1st Further Information

**Proposed Temporary Open Storage of Construction Materials and Machineries
for a Period of 3 Years and Associated Filling of Land in “Agriculture” Zone,
Lot 1110 S.C-H (Part) in D.D.106, Kam Tin, Yuen Long**

(S.16 Planning Application No. A/YL-SK/395)

Responses-to-Comments

Annex 1 – Site photos with viewpoints

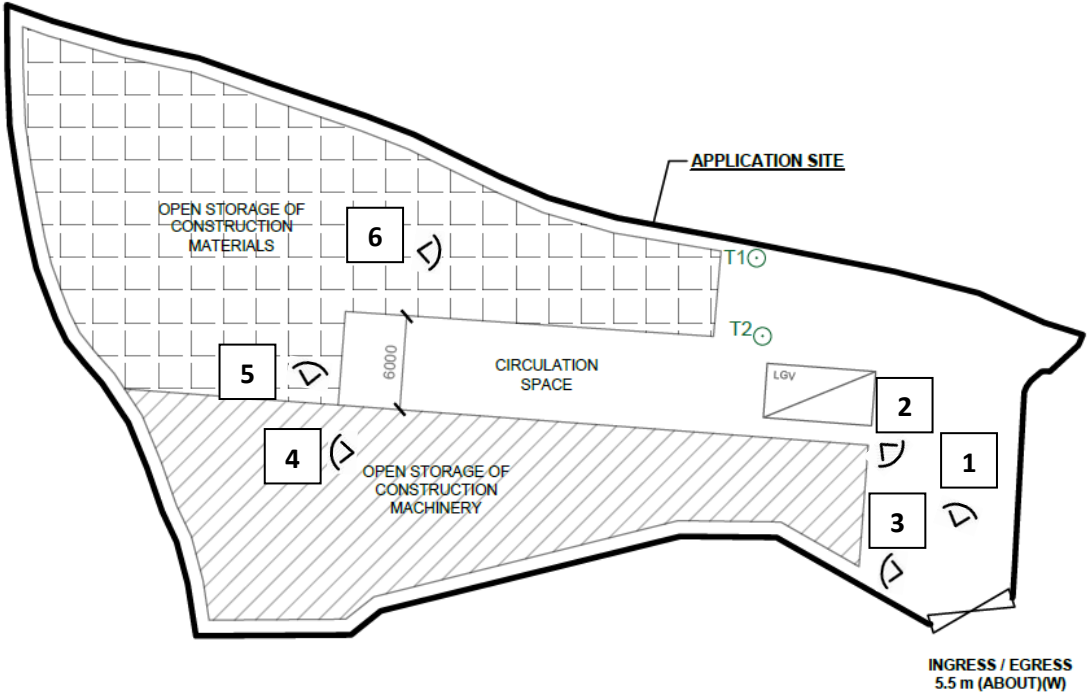
(b)	Based on the aerial photo of 2022, the Site is located in an area of Rural Inland Plains landscape character comparing of vegetated vacant lands, farmlands, village houses, scattered tree groups and open storages within the “industrial” zone to the west of the Site. There is concern that approval of the application may alter the landscape character and degrade the landscape quality of the area within the “AGR” zone.	The open storage operations will be restricted with a stacking height of not more than 2.5 m. Besides, a 2.5 m high solid metal wall will be erected along the site boundary to minimise the potential adverse landscape/visual impact to the surrounding area. Given its proximity to the adjacent “Industrial (Group D)” zone (about 80 m to the west of the Site), and similar application (No. A/YL-SK/384) was approved by the Town Planning Board (the Board) in the vicinity, it is expected that the proposed development would not adversely alter the landscape character of the “Agriculture” zone.

DWG. TITLE
LAYOUT PLAN

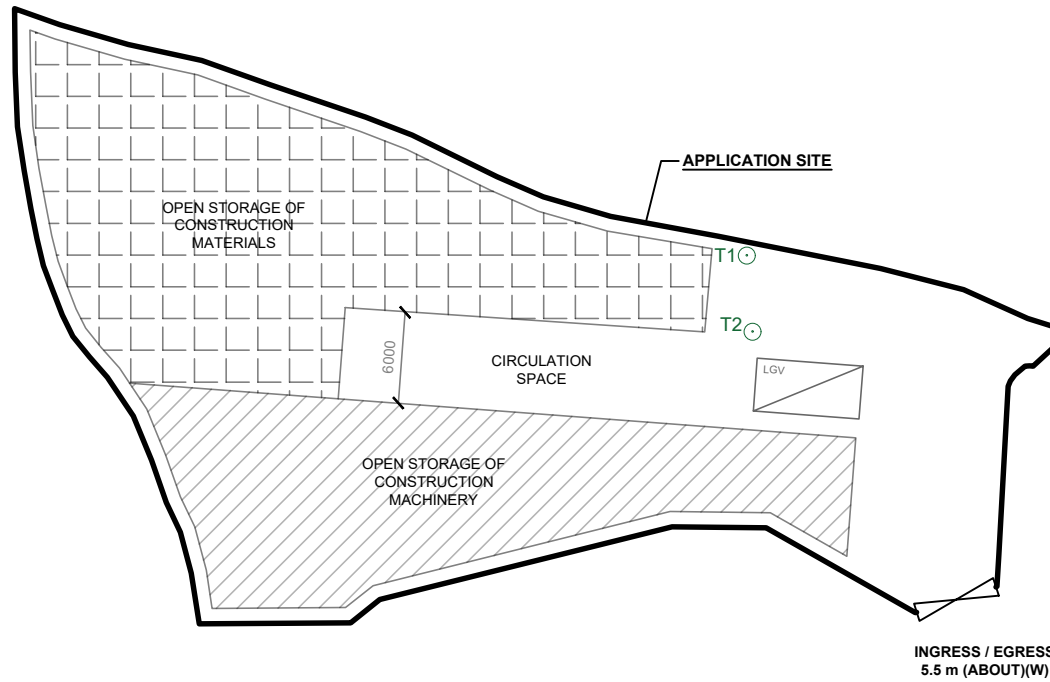
Departmental Comments		Applicant’s Responses
1. Comments of the Chief Town Planner/Urban Design & Landscape, Planning Department (CTP/UD&L, PlanD)		
(a)	No tree/landscape information is provided in the application. It is not mentioned whether there are any existing trees/significant landscape resources within the application site. According to the proposal shown in Plan 6, the entire site (about 1,626 m ²) will be filled to a depth of not more than 0.1 m. Some impact to existing vegetation is anticipated.	Recent inspection conducted on 28.11.2024 has revealed 2 nos. of existing tree within the application site (the Site). Site photos with viewpoints are shown at Annex 1 . The scale of filling of land (from 1,626 m ² to 1,594 m ²) and the area for open storage operations (from 1,044 m ² to 1,010 m ²) have been reduced with a view to preserving the existing trees in-situ. Kerbs will be installed around trees for protection. Please refer to the revised documents at Annex 2 .

NOS. OF EXISTING TREES: 2
 TREE SPECIES: T1 (*Dimocarpus longan*)
 T2 (*Celtis sinensis*)

- 1) THE APPLICANT WILL MAINTAIN TREES IN GOOD CONDITION DURING THE PLANNING APPROVAL PERIOD.
- 2) THE APPLICANT WILL REPLACE TREES WHICH ARE DYING OR DEAD DURING THE PLANNING APPROVAL PERIOD.
- 3) THE APPLICANT WILL PROVIDE ADEQUATE IRRIGATION FOR TREES.
